Moms Touch Sweater

14/2 Nayabari Road, Sataish, Tongi

15 May 2024

Observation-04: Non-structural elements not anchored or braced. (Production Building)

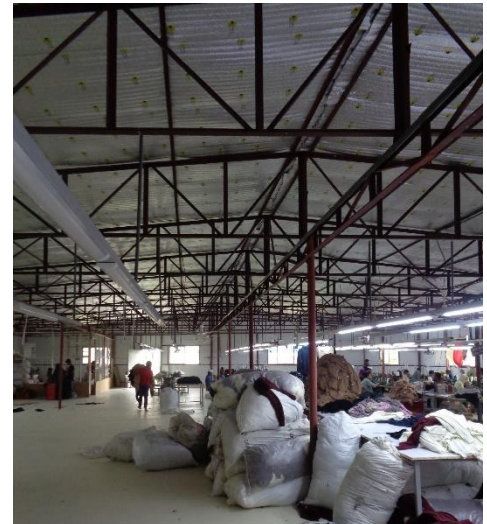
Description: Some racks on floors are not anchored or braced to resist lateral (earthquake) forces. The factory is required to anchor/brace all non-structural elements adequately to resist earthquake forces.
